Program Bulletin

CUSTOMER SATISFACTION PROGRAM

SUBJECT: Uneven Police Car Rear Tire Wear – Replace Rear Wheel Spindle Rods

**MODELS: 2007-2008 Chevrolet Impala
Equipped with Police Package (RPO 9C1/9C3)**

2129076

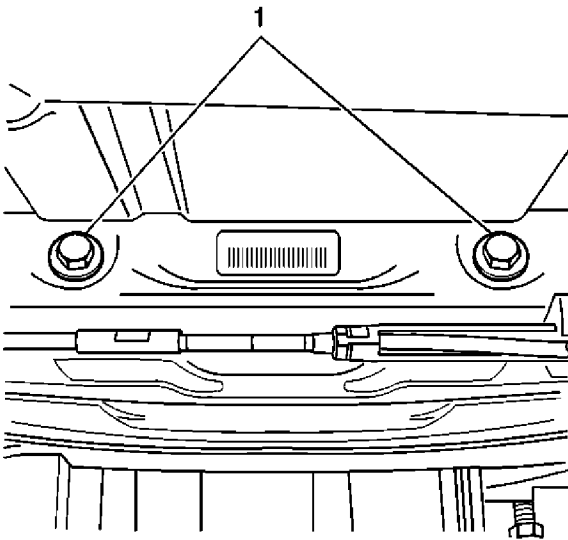
5. Remove the rear wheel spindle rod bolts (4) and nuts from the knuckles (both sides).
6. Remove the stabilizer shaft from the rear suspension support.
7. Support the rear suspension support with jack stands and remove the mounting bolts.
8. Lower the rear suspension support in order to gain access to the rear wheel spindle rod to support bolts.

9. Remove the four rear wheels spindle rod bolts (1) and nuts from the rear suspension support.
10. Remove the rear wheel spindle rods from the vehicle.
11. Install the new rear wheel spindle rods to the vehicle.

12. Install the four rear wheel spindle rod bolts and nuts to the rear suspension support.

Tighten the bolts to 135 N·m (100 lb ft).
